### REMARKS

This paper is responsive to the Non-Final Office Action dated November 10, 2004. Claims 1-42 were examined. Claims 5-7 and 28-31 stand rejected under 35 U.S.C. § 112, second paragraph. Claims 1, 41, and 42 stand rejected under 35 U.S.C. § 102(b) as being anticipated by U.S. Patent No. 6,288,950 to Koike. Claims 2-7 are objected to as being dependent upon a rejected base claim. Claims 8-27 and 33-40 are allowed. Claims 28-31 would be allowable if rewritten to overcome the rejections under 35 U.S.C. § 112, second paragraph.

AMENDMENTS TO THE DRAWINGS

FIG. 2

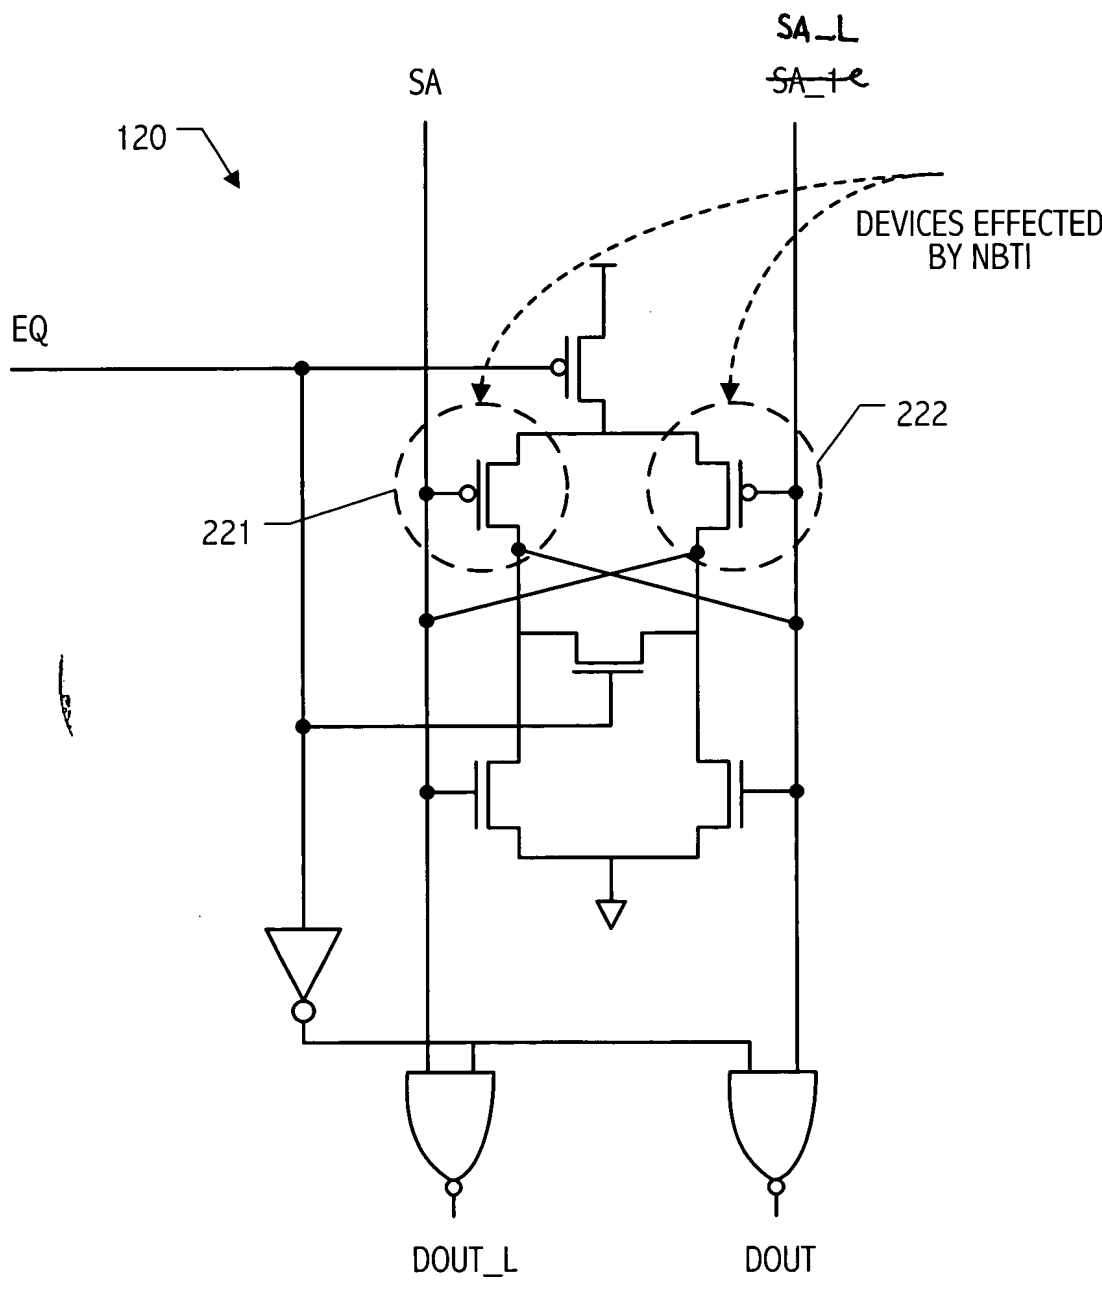
Figure 2 has been amended to indicate SA\_L, consistent with the specification. No new matter is added.
